STAFF RECOMMENDATION
602 McFerrin Avenue
May 17, 2017

Application: New construction—addition
District: Maxwell Heights Neighborhood Conservation Zoning Overlay
Council District: 05
Map and Parcel Number: 08212017100
Applicant: Kaitlyn Smous, Nine12 Design
Project Lead: Melissa Baldock, melissa.baldock@nashville.gov

<p>Description of Project: Application is to construct a rear addition.</p> <p>Recommendation Summary: Staff recommends approval of the project with the following conditions:</p> <ol style="list-style-type: none">1. The LP SmartSide lap siding be smooth and have a fiber substrate, not a strand substrate;2. Staff approve the final details, dimensions and materials of the doors prior to purchase and installation;3. Staff approve the foundation material; and4. The HVAC, if relocated, be located behind the house or on either side, beyond the mid-point of the house. <p>With these conditions, staff finds that the proposed addition meets Section II.B. of the Maxwell Heights Neighborhood Conservation Zoning Overlay design guidelines.</p>	<p>Attachments A: Site Plan B: Elevations</p>
--	--

Figure 2. The ridge raise and dormer addition

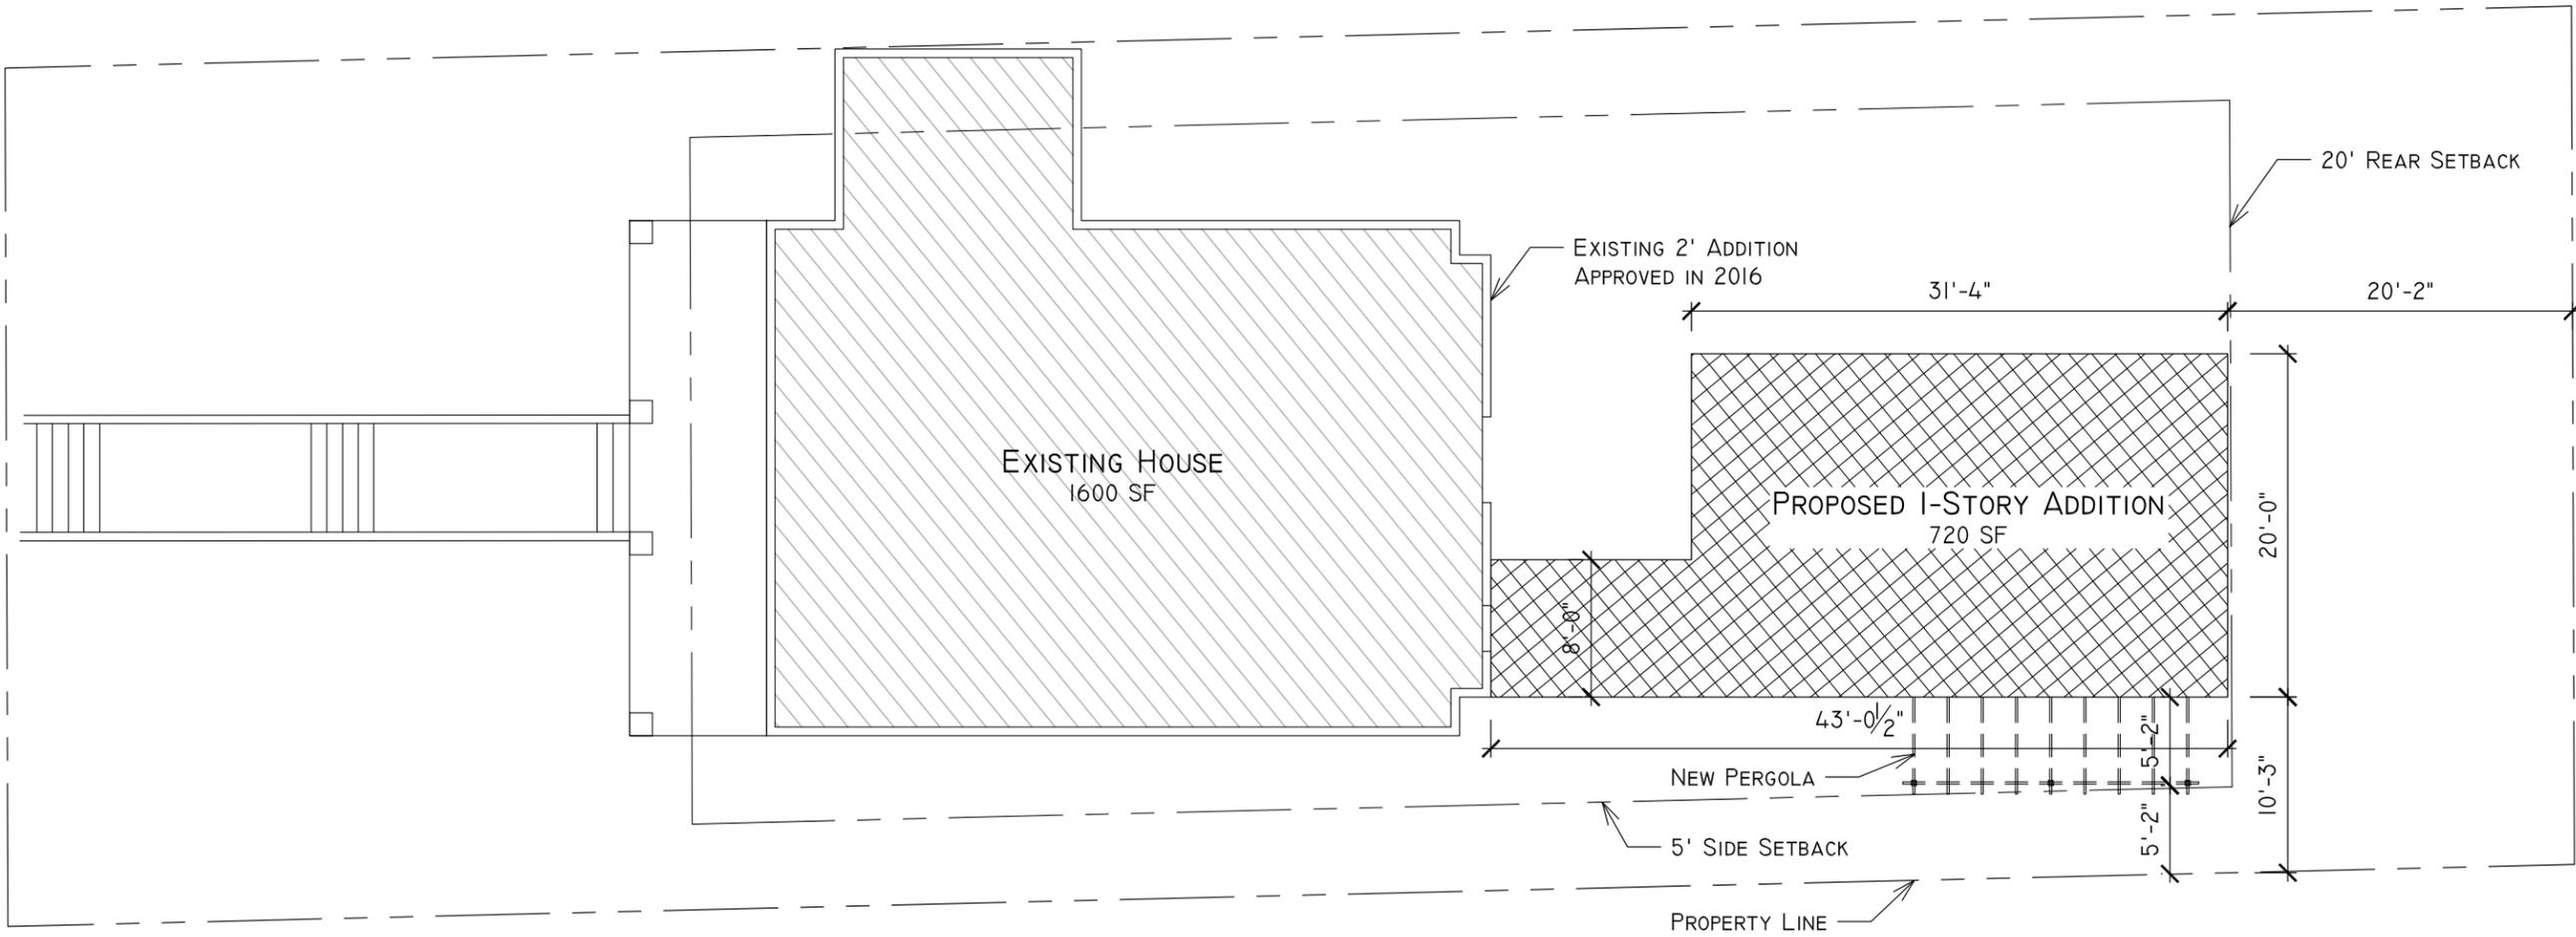
Background: 602 McFerrin Avenue is a c. 1930 bungalow that contributes to the historic character of the Maxwell Heights Neighborhood Conservation Zoning Overlay (Figure 1). In 2016, MHZC staff issued an administrative permit to construct a ridge raise and rear addition. That addition has been constructed (Figure 2).

SITE PLAN
 SCALE: 3/32"=1'-0"

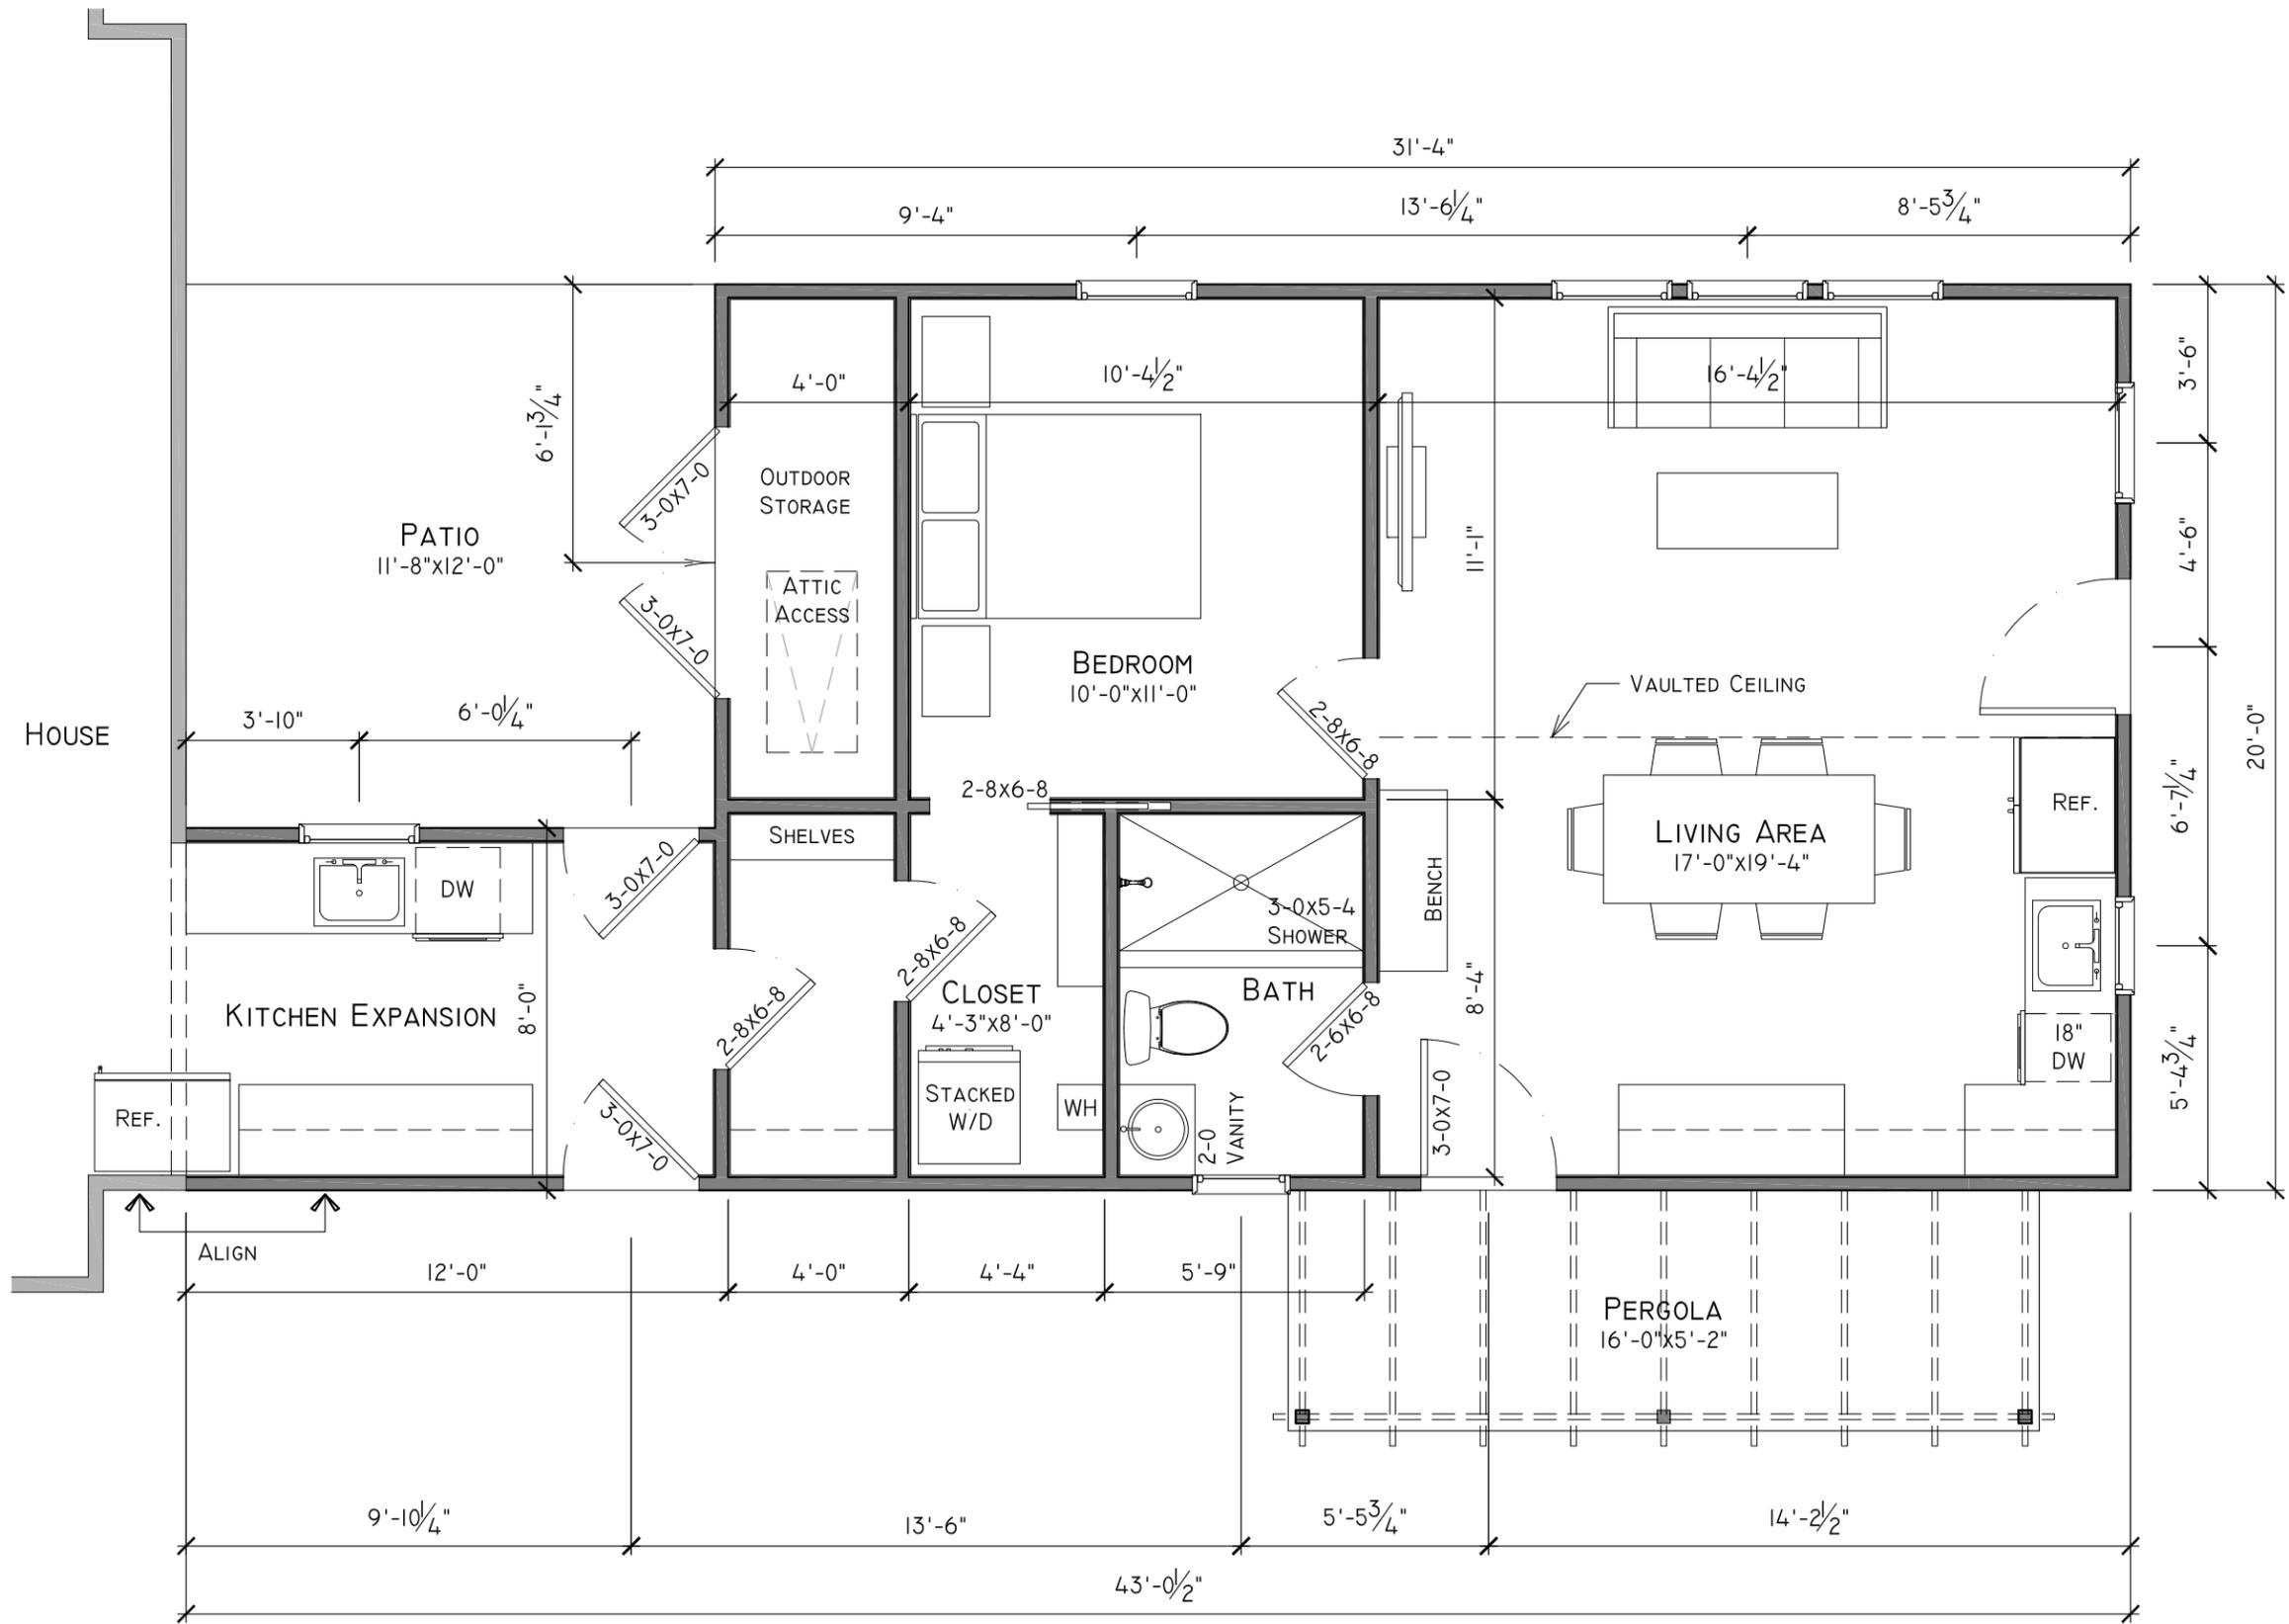
Setback & Rhythm of Spacing: The proposed addition meets all base zoning setbacks. It is at least twenty feet (20’) from the rear property line, five feet (5’) from the right side property line, and twenty feet (20’) from the left side property line. The pergola that extends wider than the historic house at the back will not affect the rhythm of spacing along the street because it is located so far back from the front of the house and will be only minimally visible. Staff finds that the project meets Sections II.B.1.c. and II.B.2. of the design guidelines.
